Errata and Added Information to
**MC68360 Quad Integrated Communication
Controller User's Manual Rev 1**

January 8, 1998

This document describes the latest information and changes to the first revision of the MC68360 user's manual.

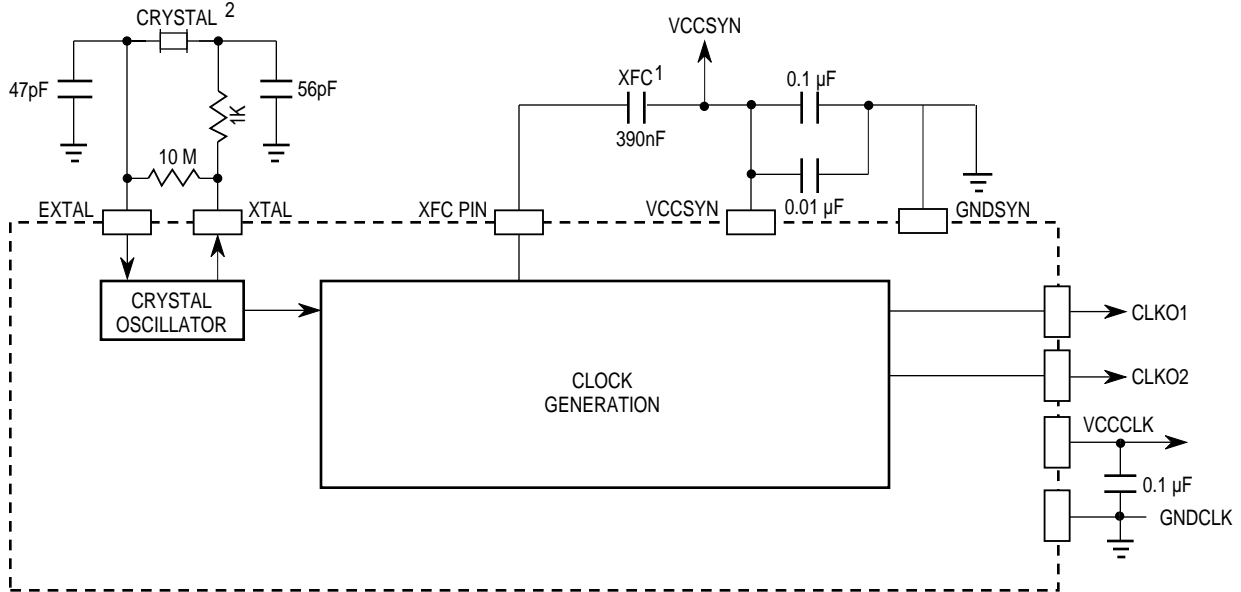
6.5.1.2 Using Crystal as Input Clock

The 68360 has the ability to use a low speed crystal as its clock source. The on-chip PLL can multiply the output of the crystal circuit up to the final system frequency. A crystal circuit consists of a parallel resonant crystal, two capacitors, and two resistors. Example values for both a 32kHz crystal and a 4MHz crystal are shown in Figures 6-6 and 6-6A. Note that these are example values. Your circuit may require slightly different values to operate properly. Crystals are typically much cheaper than similar speed oscillators. However, they may not be as stable since they are affected by parameters such as: trace length, component quality, board layout, 68360 package type, 68360 shrink level, etc. While crystal circuits are typically stable, it is impossible to guarantee that they will remain stable due to 68360 process changes or external component shifts.

Figure 10-44(a). MC68040/EC040 SRAM Read Cycles (TSS40=0, CSNT40=1)

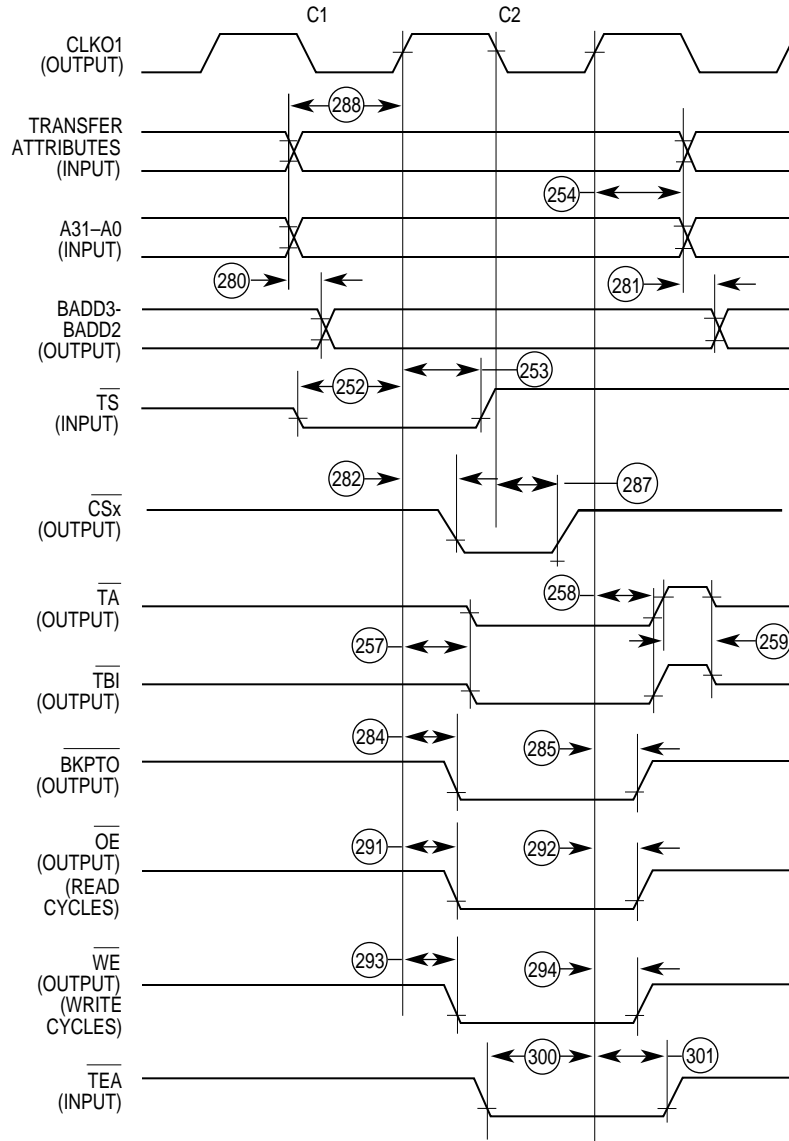
On page 10-57 the figure title should be replaced with the following

Figure 10-45(a) MC68040/MC68EC040 SRAM Write cycle (TSS40=1, CSNT40=1)

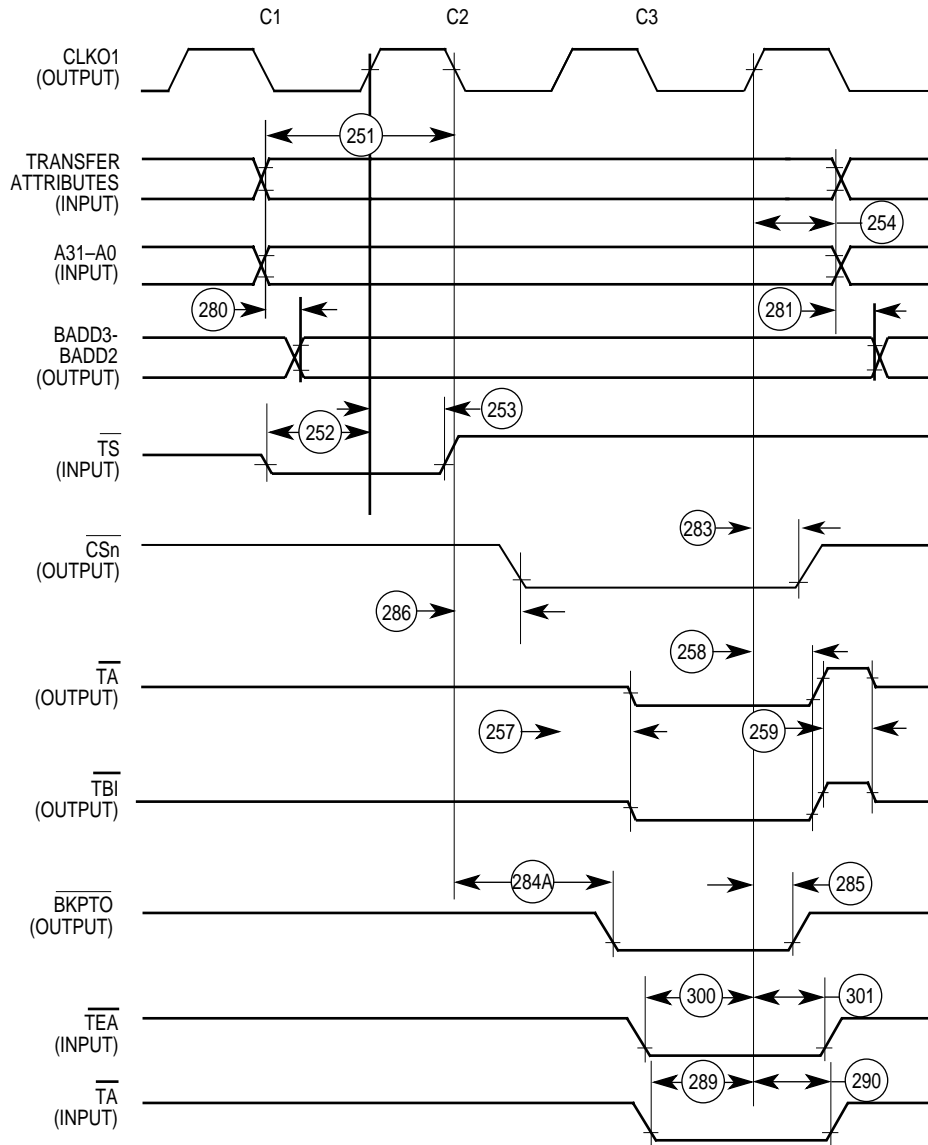
On page 10-58 the figure title for FIGURE 10-45 should be replaced with the following.

NOTE

\overline{OE} and \overline{WE} signals are not supported when TSS40 is set to 1.
